<u>MEMORANDUM</u>

Subject 4400 Ashford Dunwoody Road: Request to waive right of way dedication

requirements of Sec. 16-222

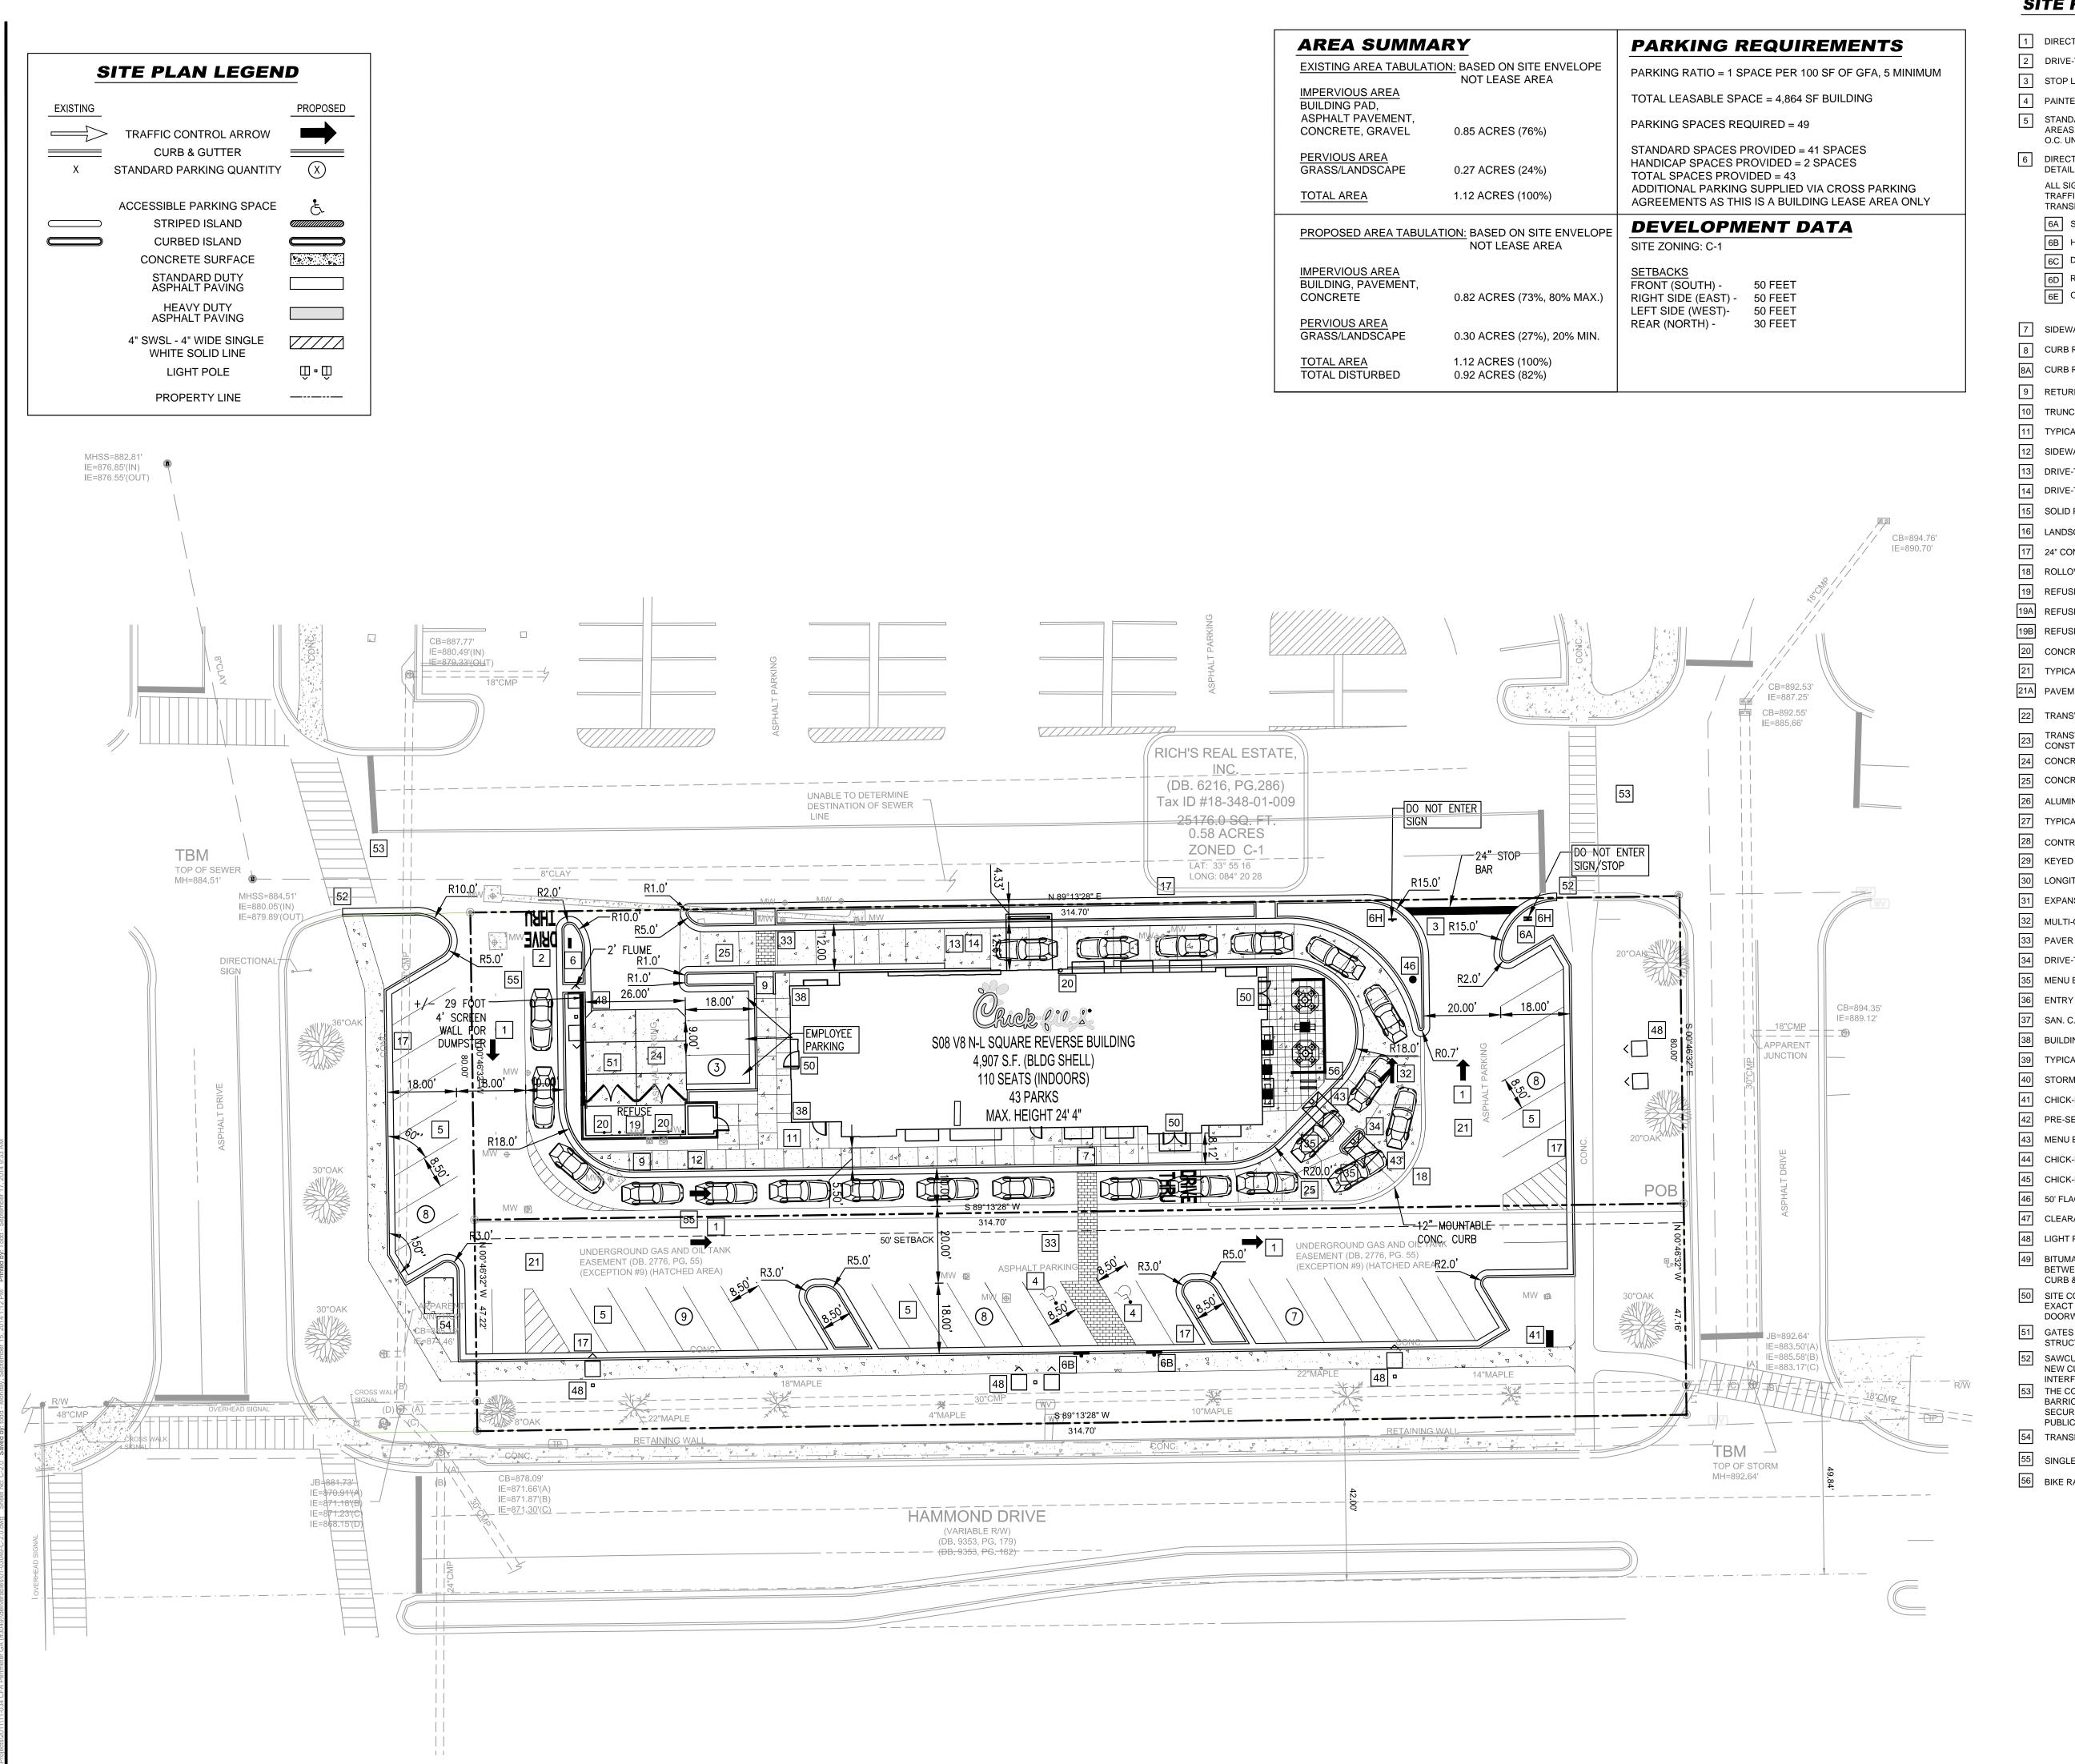
The applicant has provided a site plan that provides for a sidewalk adjacent to the parking lot with connection to the existing sidewalk along Hammond Drive at either end of the site.

At the west end of the site the connection would require steps down to the sidewalk along the street. The benefits of the proposed sidewalk location are that it would provide an ample buffer from the roadway, provide better access into the mall at the west end of the site and allow for some of the existing trees to be preserved. The primary drawback to the proposed location is that it would not be located within public right of way, and thus its continued function as a public facility could not be guaranteed.

After hearing the staff report at its October 13th meeting, the City Council indicated a desire to grant the waiver for right of way dedication with two conditions:

- The applicant will, through their lessor Macy's, request a permanent easement for public use of the proposed sidewalk between the road and the parking lot with the understanding that the applicant cannot guarantee that the easement will be granted.
- 2. The applicant will pay a fee in lieu of the sidewalk construction in the event that the property owner does not approve the sidewalk.
